RE: Permit Modification Request for Dump 1Ea for the Dicaperl El Grande Perlite Mine; Permit No. TA002RE

Dicaperl Minerals Corp
El Grande Mine
Permit No. TA002RE
Permit Modification
Application Response

**RE: Updated Closeout Plan Application Response, Permit Modification 14-1, Permit No. TA002RE,
El Grande Mine**

Figure No. A3
 WORK AREA SITE PLAN - 1Eb
 JANUARY 2016

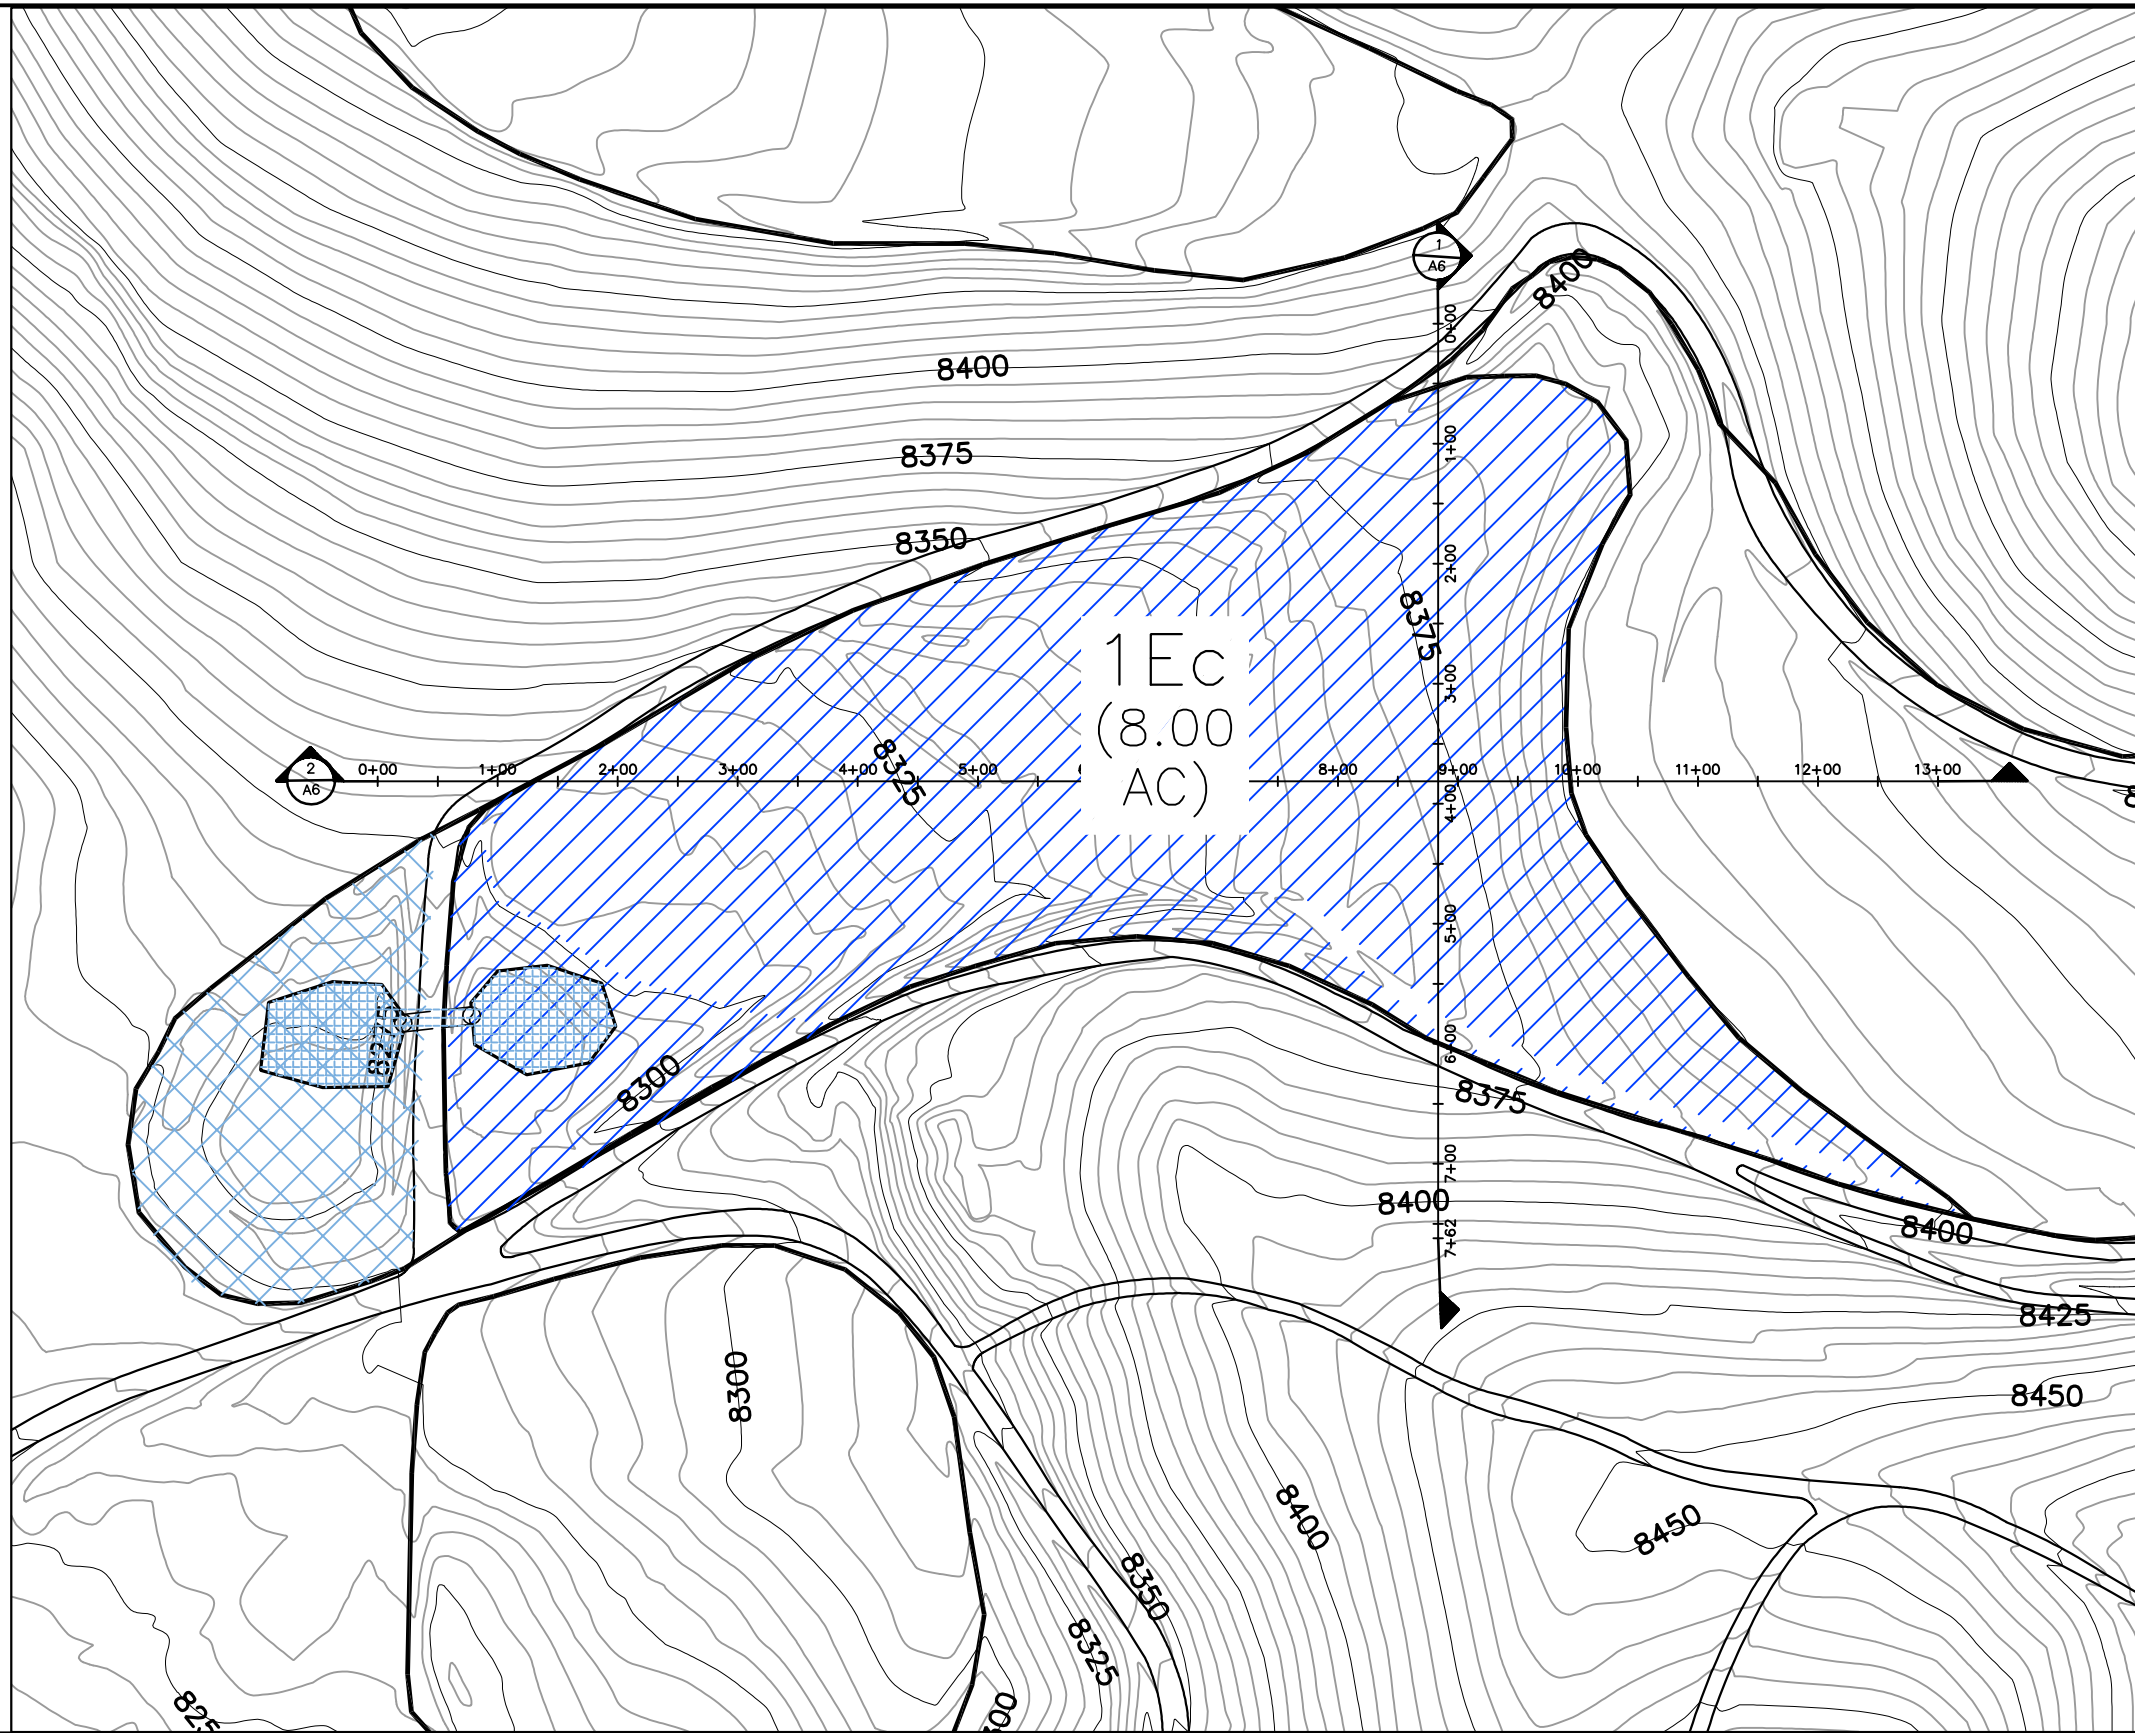
Please provide additional information: Section 3.3, Waste Receiving Plan, page 7 in the Application - states "The super sacks are covered with obsidian-rich perlite from the middle of the quarry area every 15 days or 10 truckloads. In the case of both the 1Ea and the 1Eb areas, the placement of waste will cease after the dump (and cover) elevation reach approximately 8475 feet amsl. Following completion of the dumps, they will be reclaimed in the manner described in Section 5 ". The cross-sectional drawings of the waste dumps after regrading provided in the Response for Dump No. 1E (Figure No. 5-9) do not indicate which of the 1E waste dumps are represented (1Ea, 1Eb, or 1Ee). Additionally, Figure No. 5-9 shows the final grade to be 8505 amsl while the Application states that the approximate final elevation will be 8475 feet amsl, a difference of 30feet. Please clarify which of the 1E dumps figure No. 5-9 represents and provide a minimum of two cross sectional views per dump (north-south and east-west) of the other 1E dumps and the 2A dump. Please extend the line of current existing grade on cross sectional views of dumps to show the intersection of the reclaimed (final) dump surface slope with the surrounding slopes. Additionally, please provide plain view maps of dumps 1Ea, b, c and 2A showing the post reclamation topography.

Please provide additional information: Provided in the Response, Figure #3-1-2, Work Area Site Plan dated Feb 2015 indicates that "area 1E includes sediment ponds, 1Ea, 1Eb, and 1Ee. However, there appears to be a sediment pond associated only with dump 1Ee. Please provide a map that shows the location(s) of sediment ponds for the 1Ea, 1Eb, and 2A dumps. Provide sediment pond designs to store the runoff from a 10 year-24 hour storm event, plus storage for 3 years of annual sediment deposition. It is assumed that there will be little to no vegetative cover for the first 3 years of plant growth, hence the annual sediment deposition will be greater during this time frame. Commit to maintaining the sediment ponds by removing accumulated sediment as necessary to maintain the design storm water capacity during the first 3 years after reclamation of all dumps. Provide profile and cross-sectional diagrams of the perimeter channels and a description of how the perimeter channel(s) tie into the existing, natural drainage. Include the drainage lengths and percent slope of each drainage. Provide plan-view and cross sectional drawings of the intersection of the perimeter channel(s) to the existing drainage including details of armoring, if proposed, and the percent slope of the perimeter channel and the collection channel(s).

Response: Figures representing Dumps 1E, 1Eb, 1Ec and future 2A were created to clarify final reclamation of the waste dumps. Figures associated with Dump 1Ea were previously submitted with the January 21, 2016 El Grande Mine Dump 1Ea submittal. Dumps 1Eb and 1Ec will be graded to the slope ratio of 3H:1V for the final configuration. The proposed future Dump 2A will follow the Dump Plan with the final slopes graded to 3H: 1V. The final elevation of Dump 1Eb and 1Ec will be a peak of 8485 ft above mean sea level (amsl) with the edges extending to 8475 ft amsl. Future Dump 2A will reach a final peak of 8500 ft amsl with the edges extending to 8475 ft amsl. See attached Appendix A Reclamation Design Figures for revised cross sections of Dumps 1E, 1Eb, 1Ec and future Dump 2A for final grading configuration.

Response: Figure No. 3_1-2 Work Area Site Plan was updated to include the sediment ponds associated with Dump 1Eb and future Dump 2A. The sediment ponds located near Dump 1Eb and future Dump 2A are designed to collect the precipitation and the sediment runoff from the surrounding areas. National Conservation Resources Service (NCRS) methods and calculations are used to determine the runoff amount and the annual sediment loss from the contributing area (see attached Appendix B for Stormwater Calculations). The sediment pond was designed to provide 3 years of sediment storage. The 10-year 24-hour storm event of 2.03 inches of precipitation is used for the runoff calculation. NCRS charts are used to estimate the annual sediment loading from areas Dump 1Eb and future Dump 2A. A curve number (CN) of 85 referenced from the NCRS TY-55 manual is used in the runoff calculation representing sagebrush with a grass understory condition found in semiarid regions of the country. A poor hydrologic soil condition was assumed.
